**ADDENDUM STATE ENVIRONMENTAL POLICY ACT DETERMINATION OF NONSIGNIFICANCE (DNS)
WEST SEATTLE ELEMENTARY SCHOOL ADDITION PROPOSAL**

Original Issuance Date: Nov. 3, 2020
Addendum Issuance Date: April 26, 2021
Lead agency: Seattle Public Schools
Location of proposal: West Seattle Elementary School, 6760 34th Ave. NW, Seattle, WA
(SW Qtr of NW Qtr, Section 25, Township 24, Range 3)

West Seattle Elementary School Addition Project

Addendum to the Final SEPA Checklist

Source: Seattle Public Schools, 2021.

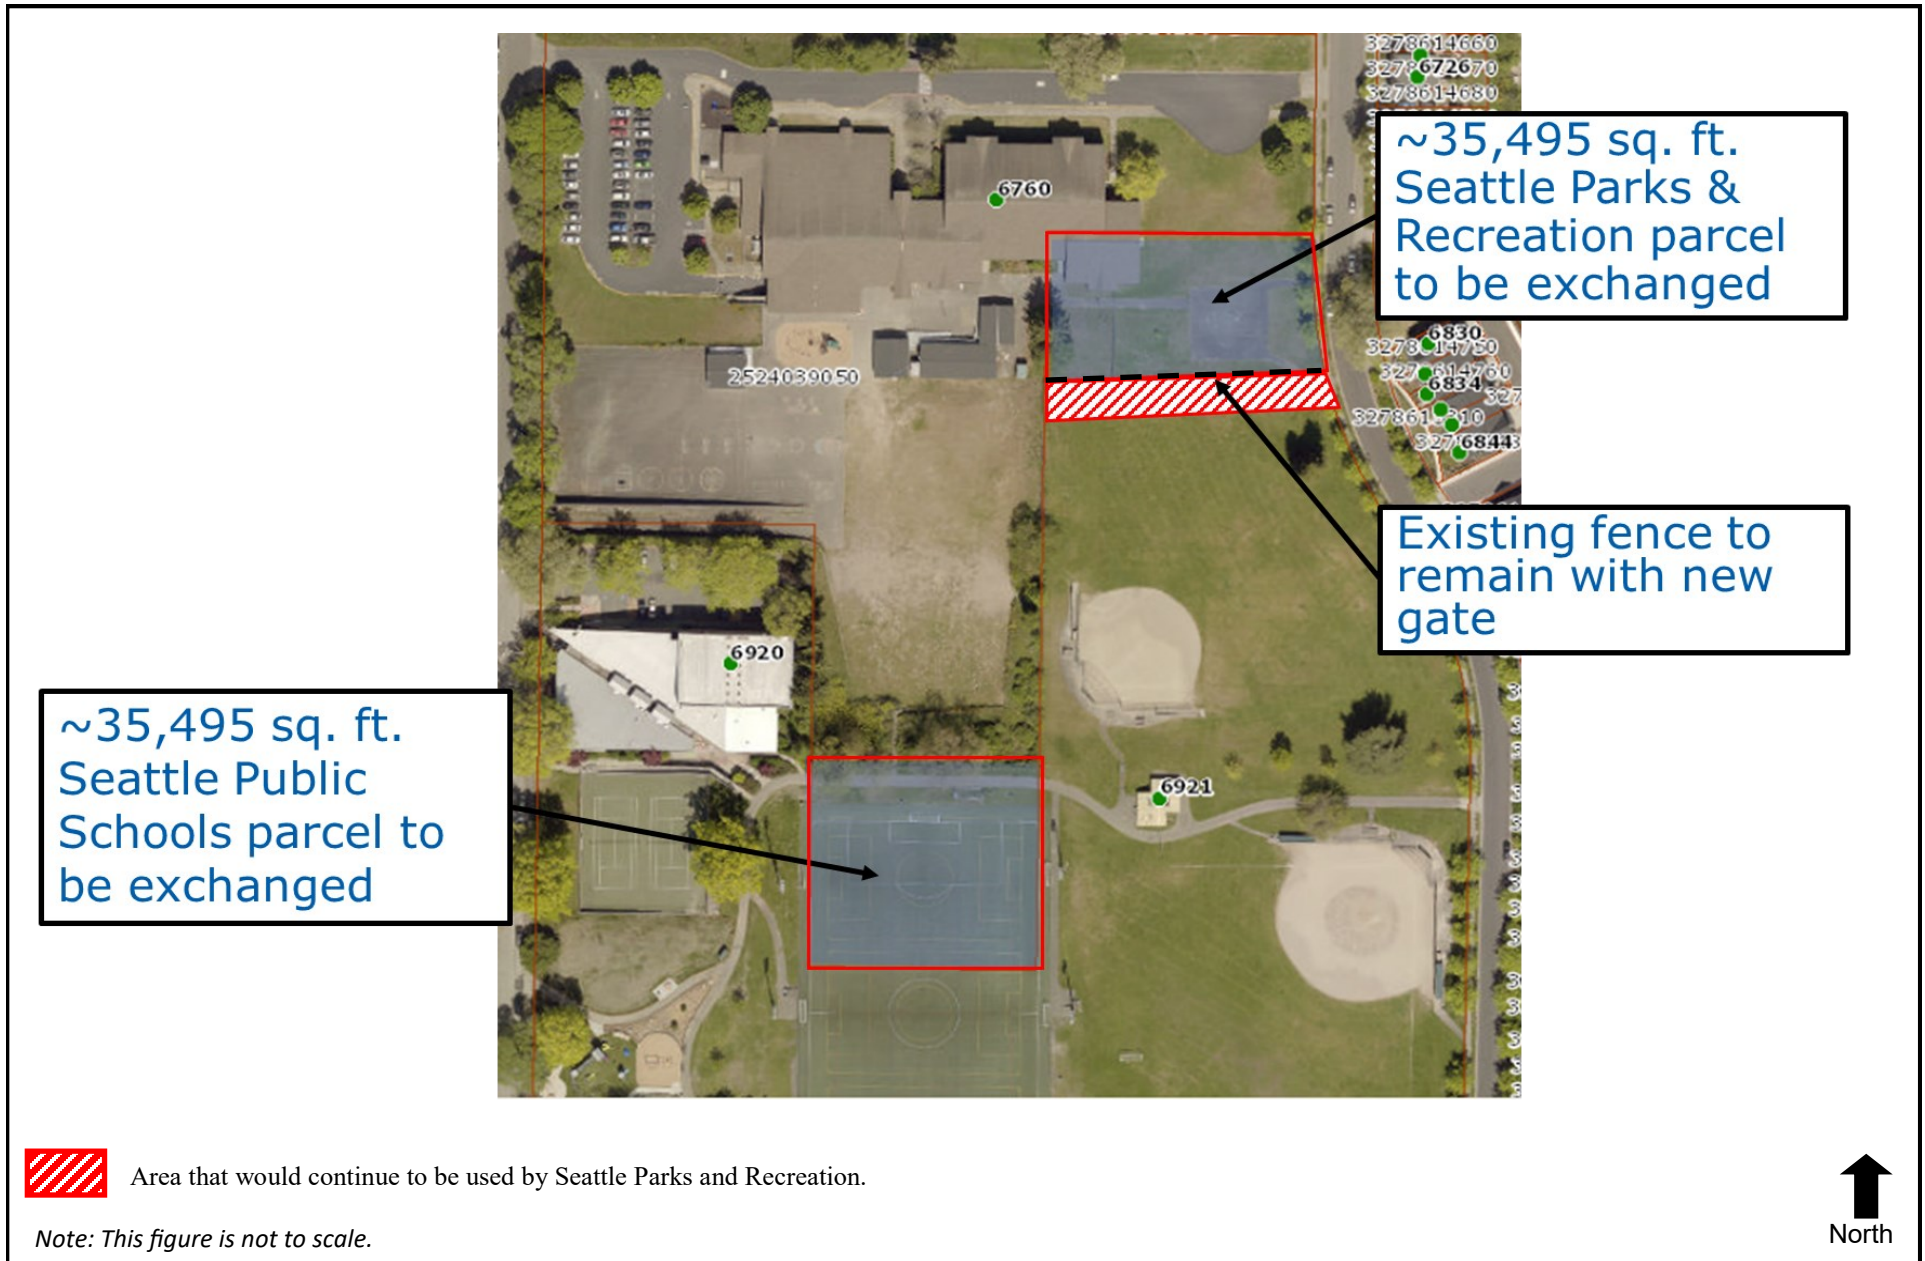
Description of proposal (changes underlined) – The proposal would add approximately 21,400 square feet of new permanent building space and renovate portions of the existing building; the five existing portables would also be removed from the site. With the completion of the project, the school building would be approximately 71,400 square feet. There is an option to add approximately 3,000 square feet of covered play area in the southwest corner of the campus within the existing hard surface play area. The building addition would increase student capacity from the existing 378 students to approximately 500 students (current enrollment is approximately 427 students). No change to bus and parent vehicle access or the parking lot would occur. Existing recreation space would be expanded and renovated, including the hard surface play area, new play structures, a new student garden area, and a renovated grass field. School Board and City Council action is also required to correct property ownership between SPS and Seattle Department of Parks and Recreation by completing the land exchange that was mistakenly understood to have been finalized in 1987. This SEPA Addendum is issued to document the need for this minor additional action that will not result in changes to the existing or proposed uses of the two parcels.

Both a portion of the existing building and a portion of the proposed building addition are located on property currently owned by Parks. In 1987, Seattle Public Schools and Parks signed and recorded a Lot Boundary Adjustment (LBA) that was incorrectly understood at the time to be a legal property exchange. During the design phase of this classroom addition project, it was discovered that the land exchange was not effectuated. School Board and City Council approval is required to correct the property discrepancy and properly exchange the property. The land exchange will exchange
